LANDSCAPE CALCULATIONS

Reviewed by Community & Economic Development

See Review Comments

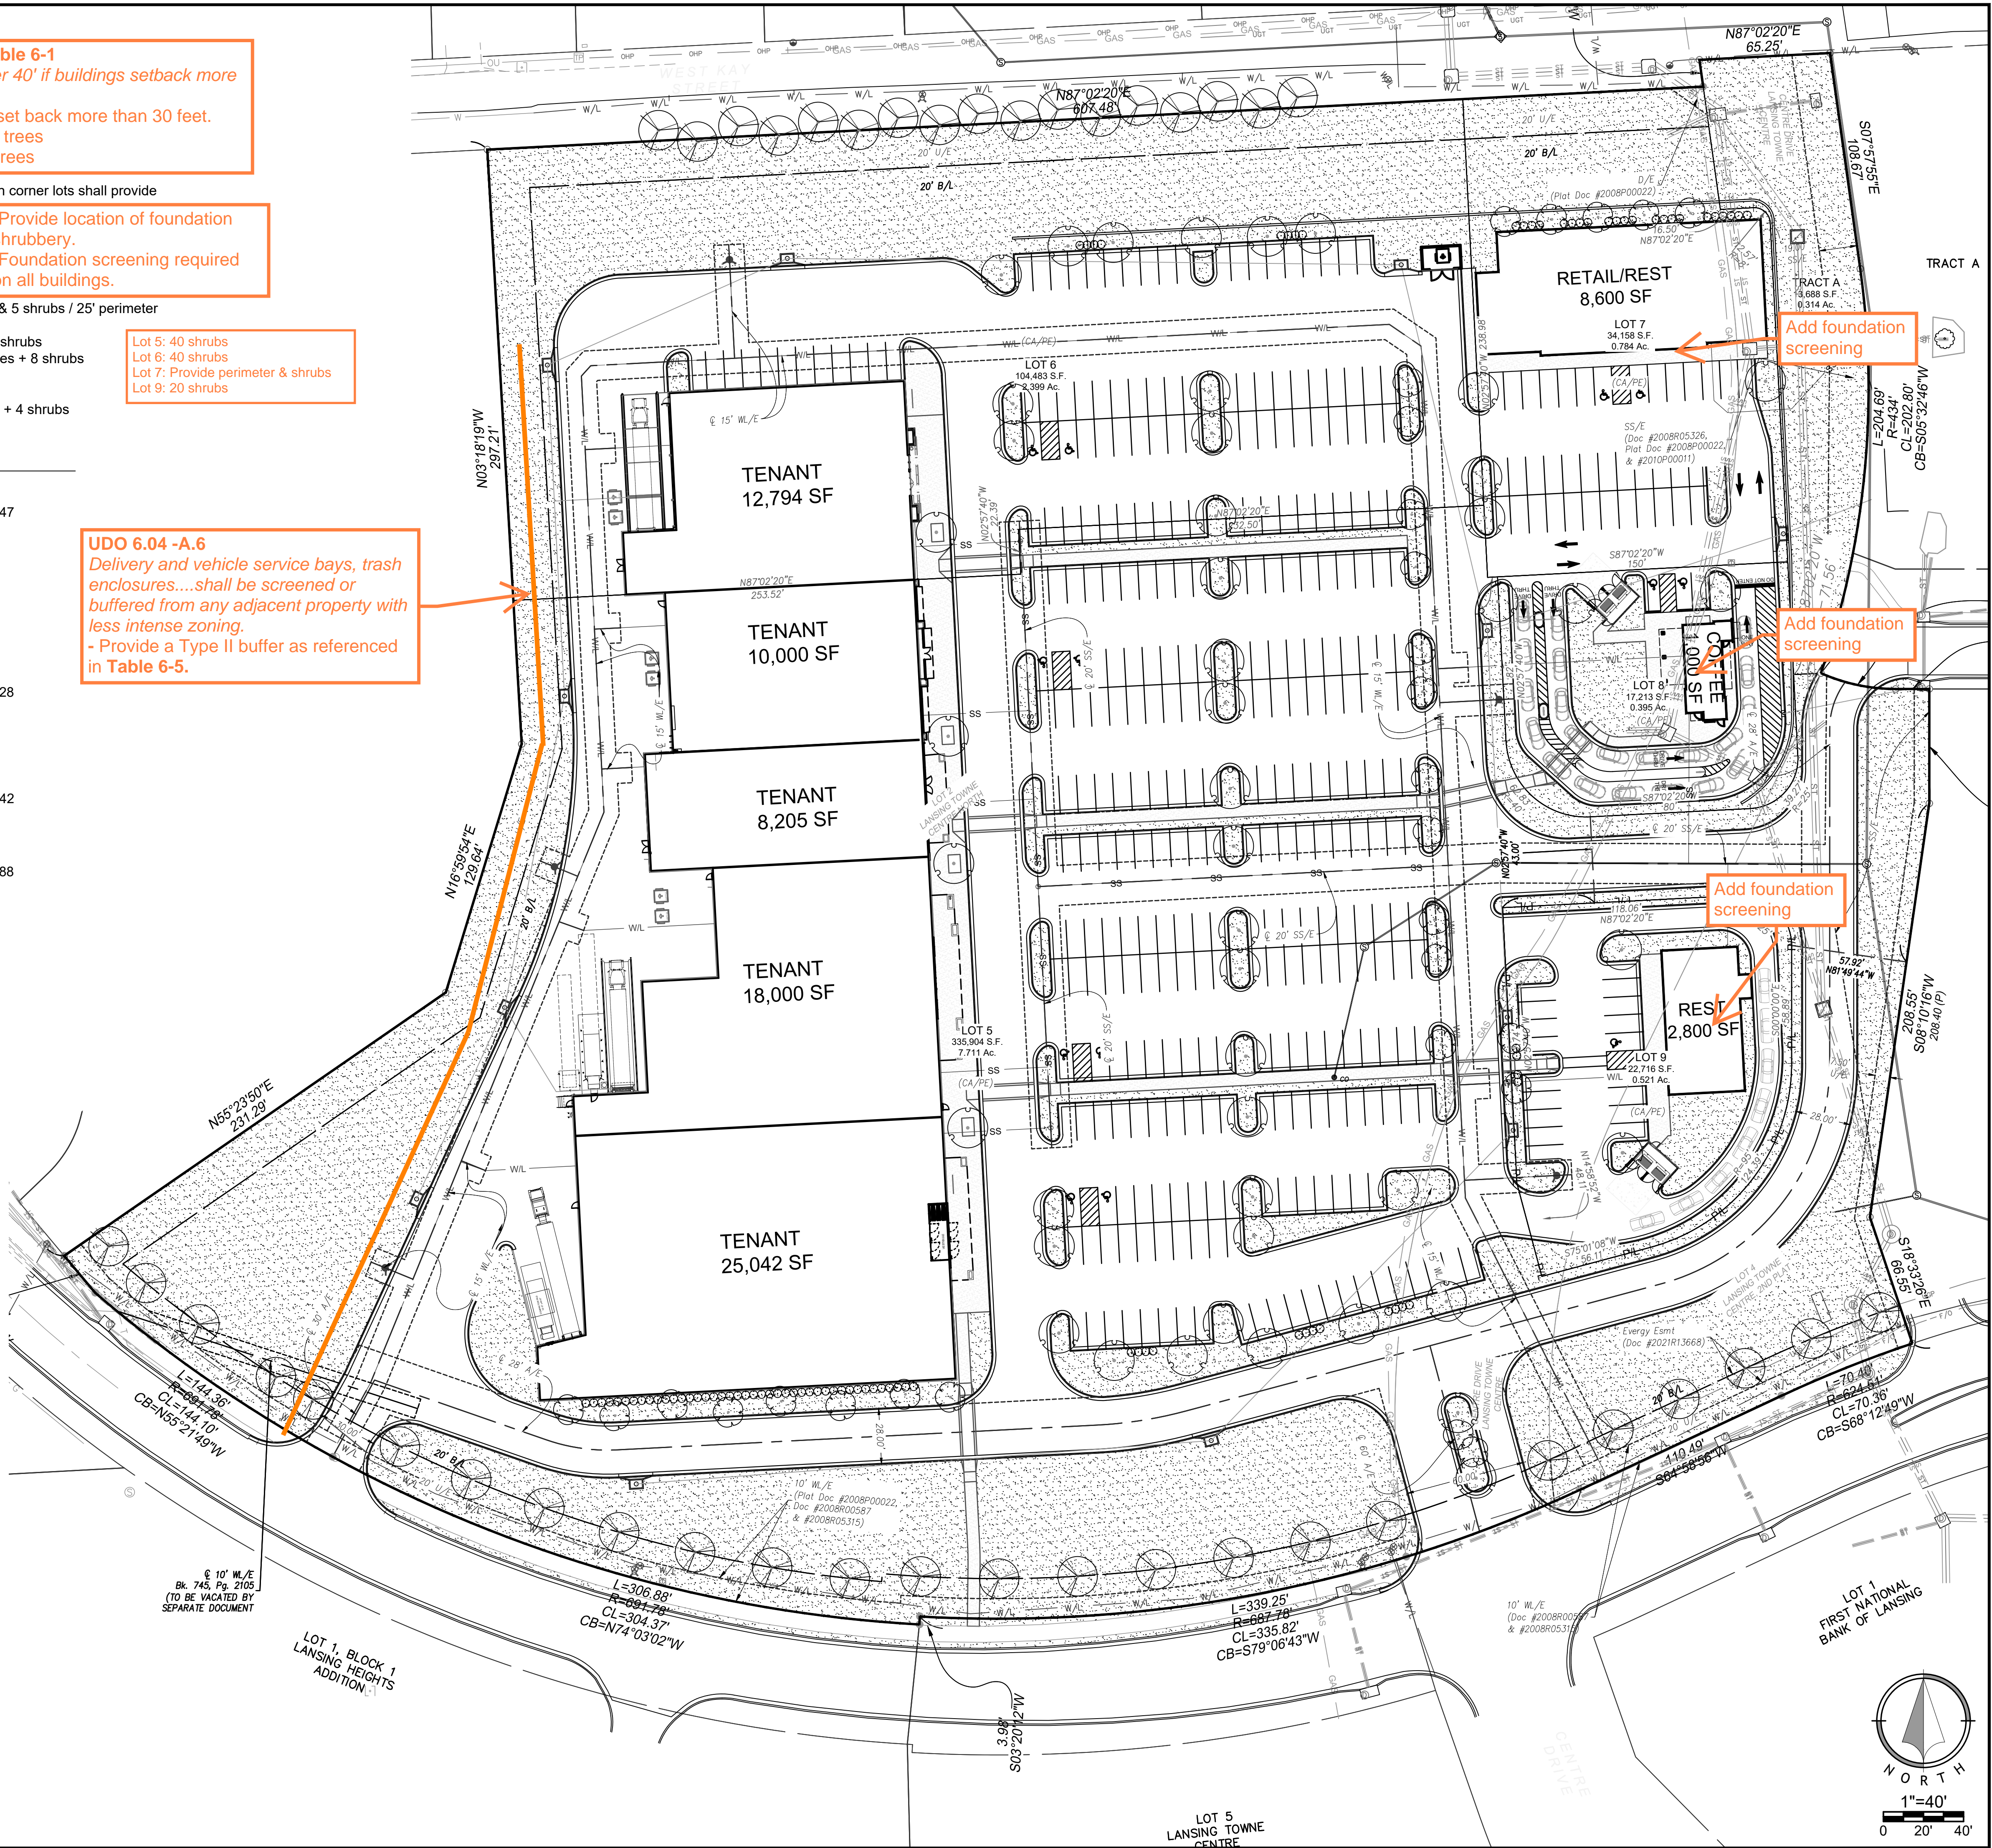
UDO 6.03 A Table 6-1

2 large trees per 40' if buildings setback more than 30'.

- Buildings are set back more than 30 feet.
Mary Street: 50 trees
Kay Street: 34 trees

-Provide location of foundation shrubbery.

-Foundation screening required on all buildings.

Lot 5: 40 shrubs
Lot 6: 40 shrubs
Lot 7: Provide perimeter & shrubs
Lot 9: 20 shrubs

UDO 6.04 -A.6

Delivery and vehicle service bays, trash enclosures....shall be screened or buffered from any adjacent property with less intense zoning.

- Provide a Type II buffer as referenced in Table 6-5.
